SUBJECT: IFB #11-0579-OV / Downtown Bradenton Transit Station
Location: 601 13th Street West, Bradenton, FL
(Manatee County)

ADDENDUM #1

PROJECT NAME: DOWNTOWN BRADENTON TRANSIT STATION

ADDENDUM NUMBER 1

CONSTRUCTION SIGNAGE

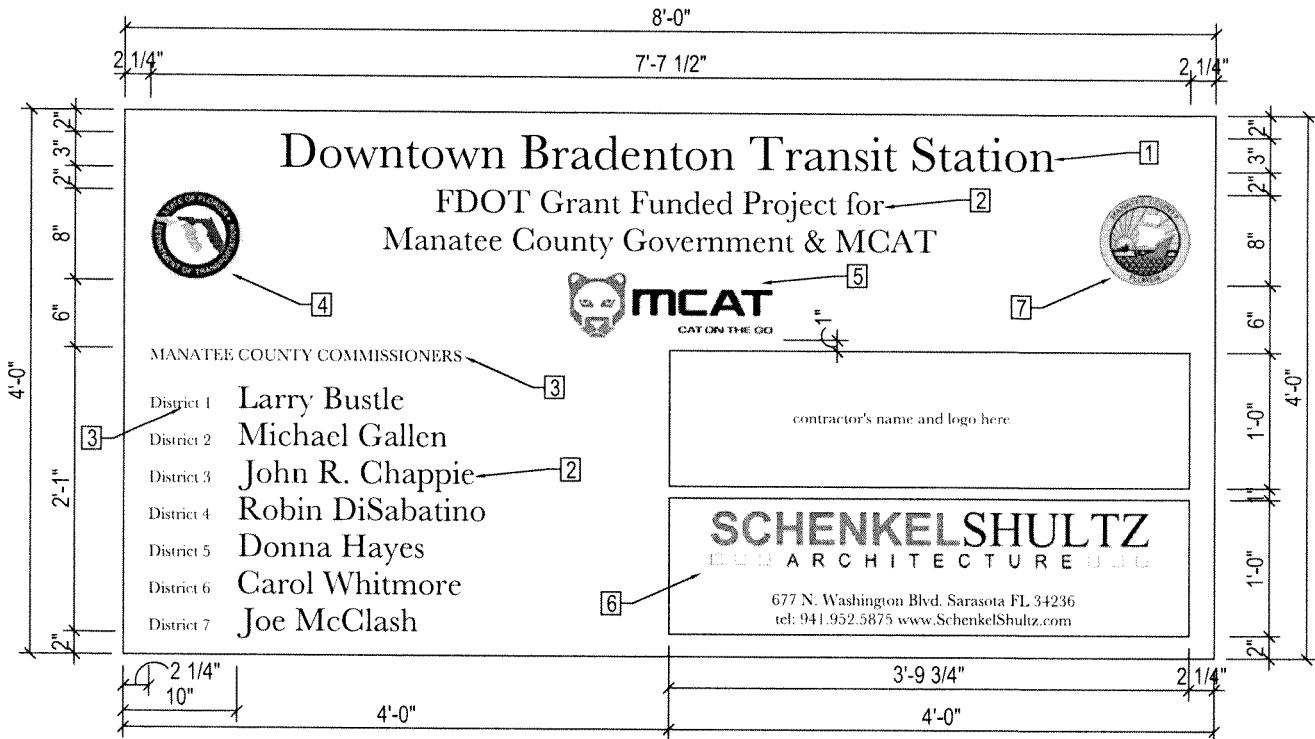
Clarification 3: Modified construction sign sketch is attached to this addendum. One (1) sign shall be provided by the successful Contractor.

- 1- Sign shall be 4'x8'x3/4" Exterior grade plywood.
- 2- Paint all sides and edged of the sign white. Letters shall be black.
- 3- Logos shall be in color as required.
- 4- Sign shall be mounted on 2 - 4x4 white painted wood posts, exterior grade.
- 5- Verify the sign location with the County and the Architect.
